MICROLIGHT AIRWORTHINESS APPROVAL NOTE

MAAN NO: 2159

TITLE: Microlight Airworthiness Approval Note 2159: inspection and modification of the elevator bias spring attachment bracket SUP8

APPLICABILITY: UK Savannah aircraft with the manual (bungee) pitch trimmer fitted

Figure 1: schematic of elevator 'down' spring installation.

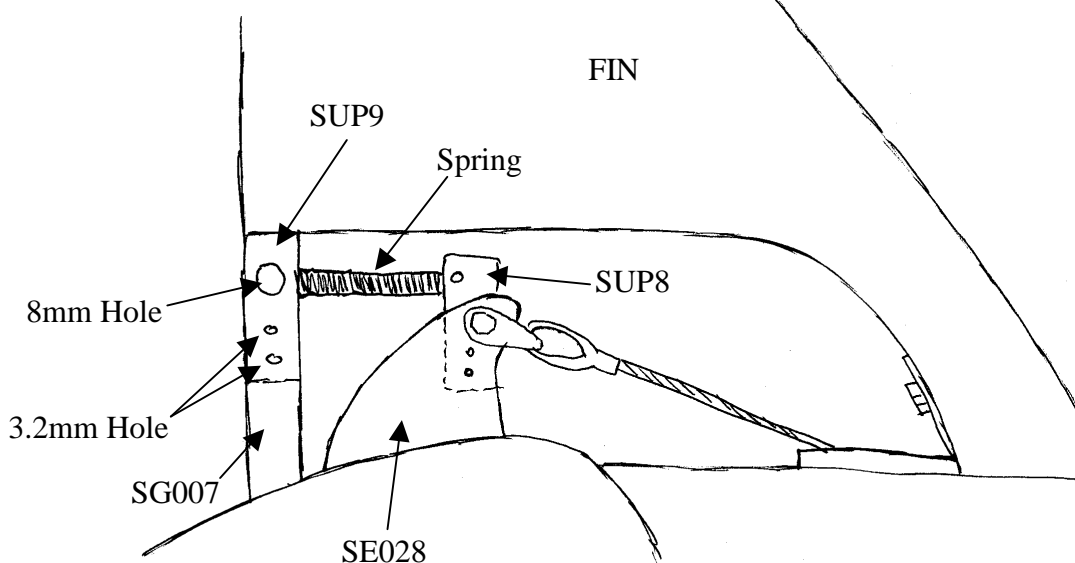
UK Savannah aircraft with the manual (bungee) pitch trimmer fitted have an elevator bias spring mechanism fitted in the tail. See figure 1 in appendix A to the service bulletin. This mechanism includes a plate, SUP8, that is attached to the elevator control horn, SE028. On one aircraft it was discovered that the elevator control cable came into contact with SUP8 at one extreme of elevator movement (elevator fully down; stick fully forward). See figure 2 in appendix A to the service bulletin. This is unsatisfactory because the elevator control cable will wear over time and could eventually fail. As the location of SUP8 on SE028 is not specified precisely in the build manual it is possible that other aircraft have a similar fault.

UK Savannah aircraft with the manual (bungee) pitch trimmer fitted have an elevator bias spring mechanism fitted in the tail. See figure 1 in appendix A. This mechanism includes a plate, SUP8, that is attached to the elevator control horn, SE028. On one aircraft it was discovered that the elevator control cable came into contact with SUP8 at one extreme of elevator movement (elevator fully down; stick fully forward). See figure 2 in appendix A. This is unsatisfactory because the elevator control cable will wear over time and could eventually fail. As the location of SUP8 on SE028 is not specified precisely in the build manual it is possible that other aircraft have a similar fault.

1. Within 10 hours or before the next inspection for revalidation of the Permit to Fly, whichever is the sooner, remove the inspection panel and inspect the attachment of the elevator control cable to the elevator control horn, SE018. See figure 1 in appendix A. The control cable should **not** contact bracket SUP8 through the full range of elevator movement: stick fully forward to stick fully back. See figure 2 in appendix A.

- 2.1 To ensure the elevator control cable does not contact SUP8 the elevator cable should be disconnected and SUP8 filed down at the point of contact until the control cable remains clear. The final profile must be smooth without any sharp steps. The filed area should be protected using a non-flexible paint and the elevator control cable reconnected. A new split pin must be used. Under no circumstances must the elevator control horn, SE028, be modified.

Figure 2: photograph showing contact between elevator control wire and SUP8.

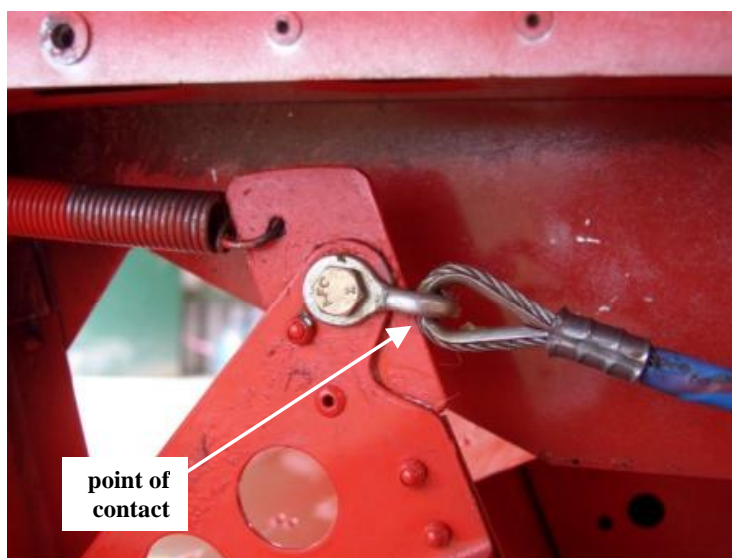
2. If the control cable **does** contact the bracket remedial action must be taken:
 - If the elevator control cable is damaged remedial action must be taken before flight (see paragraphs 2.1, 2.2 and 2.3 below).

- 2.2 If the control cable is damaged – for example if the cable is badly worn or any strand broken – it must be replaced in accordance with the approved build manual. Slight ‘polishing’ or a slight flattening of the control cable at the point of contact is not considered significant.
